Dam Safety Inspection Report

Fischer Park No 1 Dam

TX07410

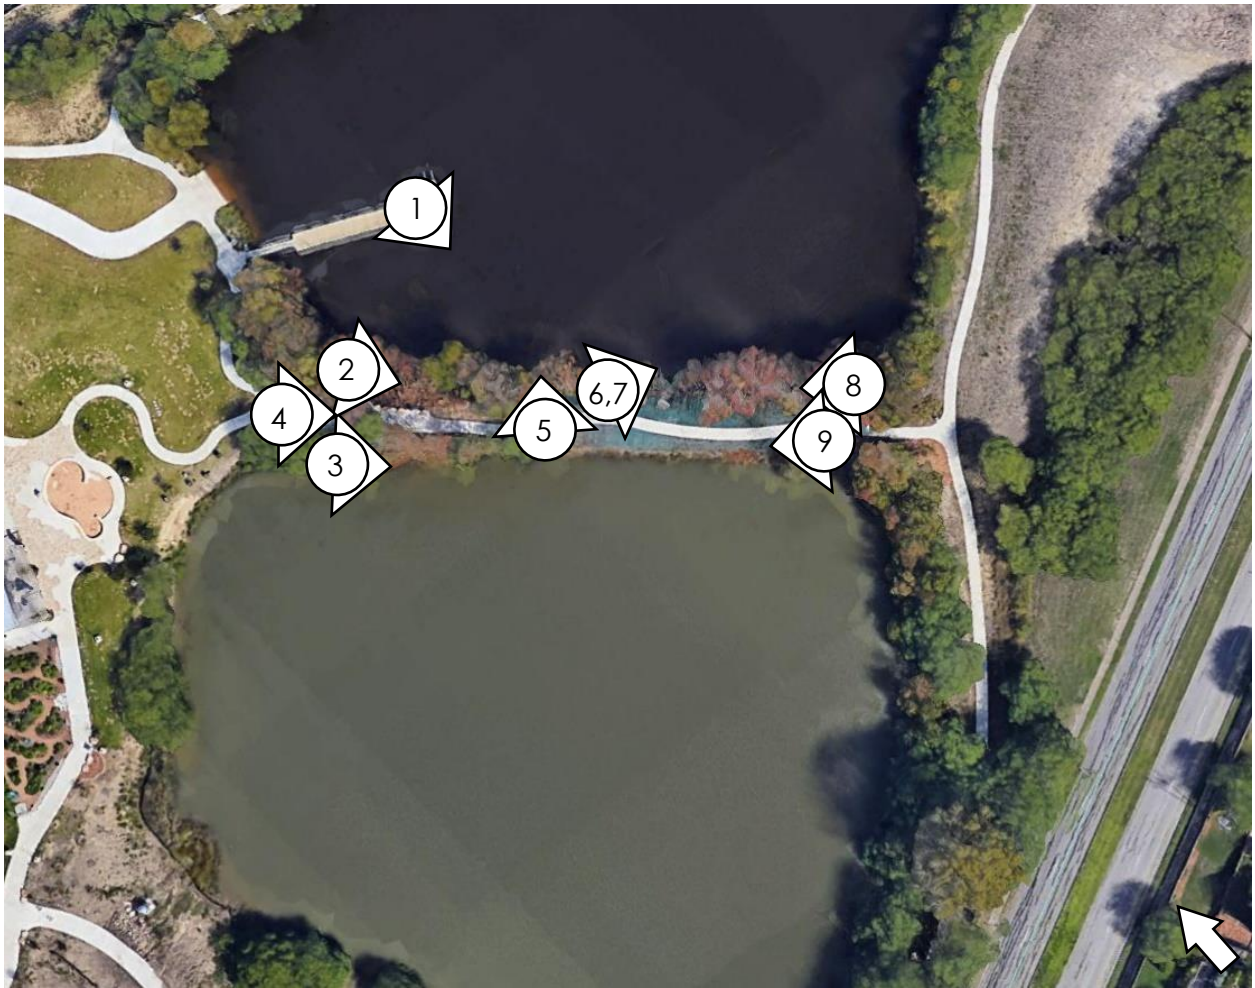
The auxiliary spillway consists of a 150-foot-wide low area along the embankment protected from erosion by TRM. The sidewalk serves as the crest and control section of the spillway. The spillway was found to be in poor condition. Photos 5 through 9 show the spillway.

- The TRM lacked an adequate cover of grass which is necessary for proper performance of the matting. Isolated areas on the upstream portion of the spillway had adequate cover.
- The TRM did not have intimate contact with the soil along nearly the entire downstream portion of the spillway. Intimate contact is necessary for proper performance of TRM. Erosion below the TRM was evident along the entirety of the downstream slope of the spillway.
- The area immediately downstream of the TRM anchor trench was eroded, creating a benched area.
- Regular flow over the sidewalk has resulted in growth of algae which can present a safety hazard to pedestrians. The spillway was not overflowing at the time of the inspection.

5. The TRM spillway has failed and requires modifications or repairs:
 - a. TRM over an earthen embankment is not appropriate for the service spillway to maintain the normal level in the pond because regular flows prevent establishment of grass cover over the matting. Flows over the spillway, shade, and loss of intimate contact with the subgrade have limited the effectiveness of the TRM to prevent erosion of the embankment.

- b. This configuration also presents a safety hazard because the water regularly passing over the sidewalk results in growth of algae which can be slippery to pedestrians.

- c. FNI recommends that the spillway be repaired or modified to address these issues for improved long-term performance. At a minimum, repairs should include measures to pass normal flows below the sidewalk, additional erosion protection downstream of the spillway, and repair/replacement of the failed TRM.
